**Project:** **Mount Joy Warehouse Park**  
Mount Joy Township, Lancaster County, PA

**Subject:** Transportation Impact Study (TIS) Scoping Meeting

**Draft Scope Application Cycle 1 Comment Sheet**

DISTRICT	COUNTY	ROUTE	SECTION	SHEET
8-0	LANCASTER	4025	--	2 OF 4

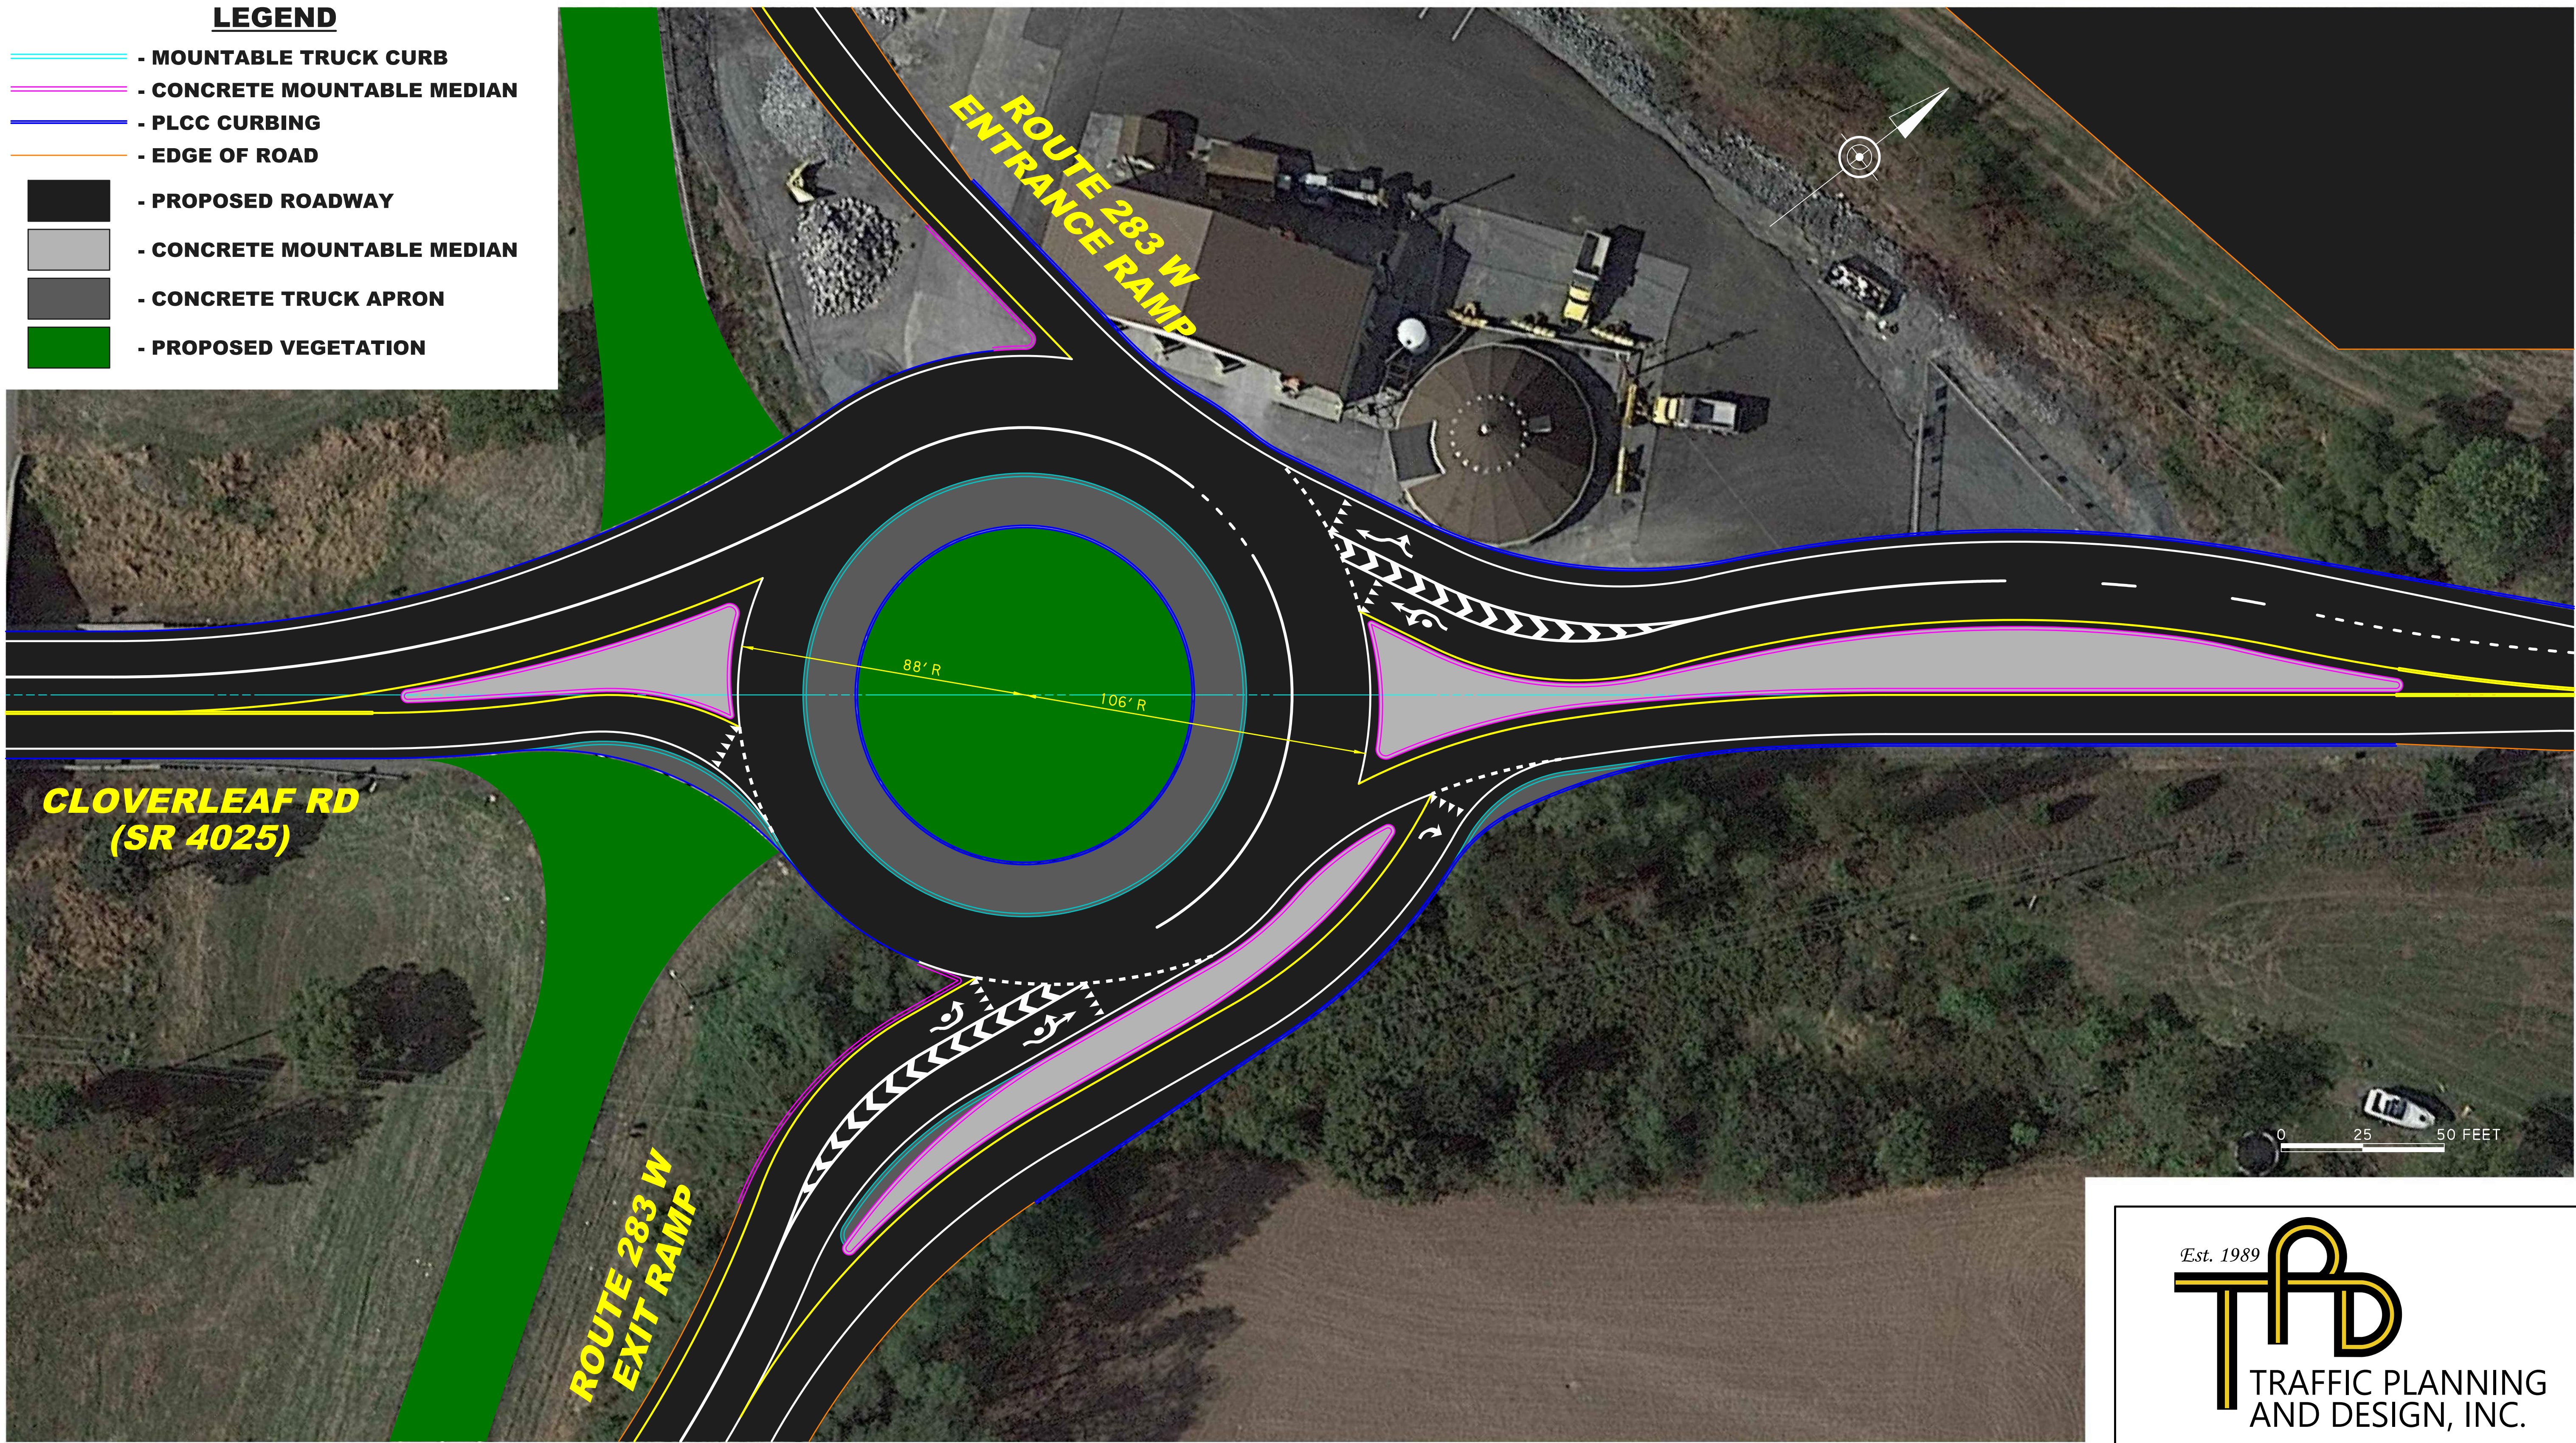
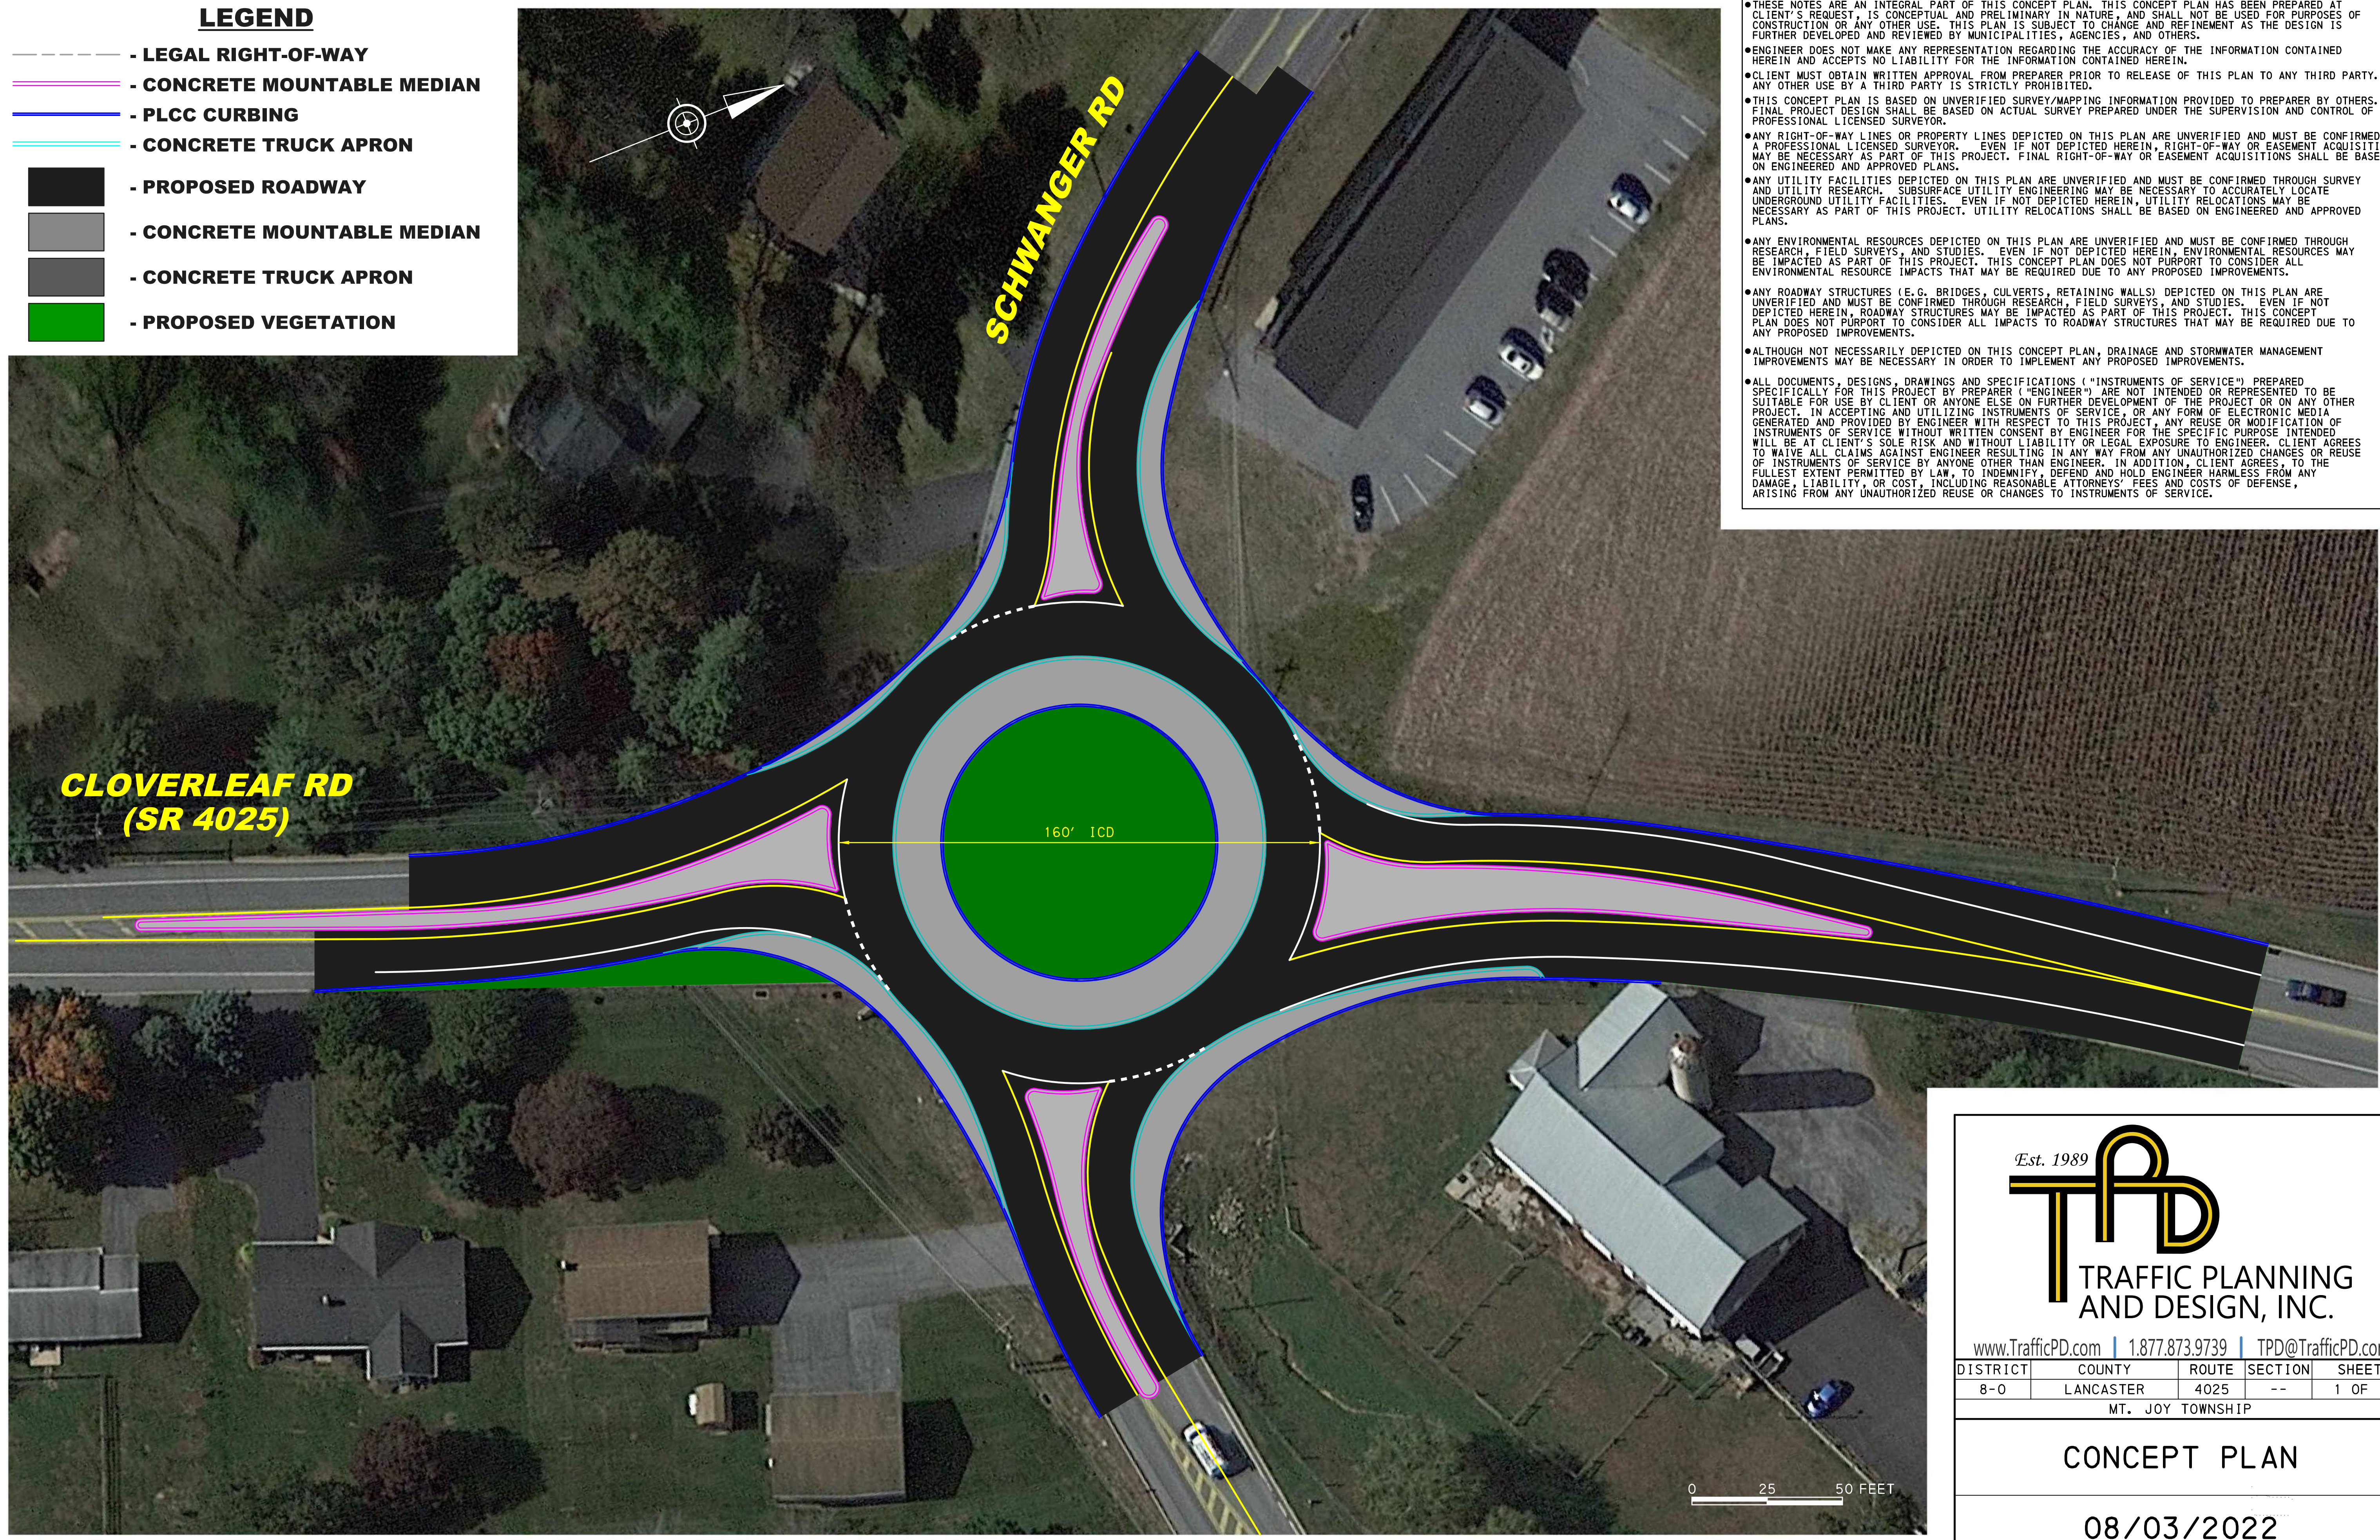
- » Eric Kinard questioned if Jarred ever worked with any development involving PennDOT properties/storage sheds. Bill Warden mentioned to reach out to PennDOT roadway department to discuss the process. Warden questioned if there was an alternate site proposed for PennDOT storage shed. Jarred indicated, Panattoni currently has the parcel of land directly to the north of the shed under option to purchase, the land will be subdivided and dedicated to PennDOT in order to construct the maintenance shed and Park-and-Ride as shown on attachment Concept D1 (orange outline).
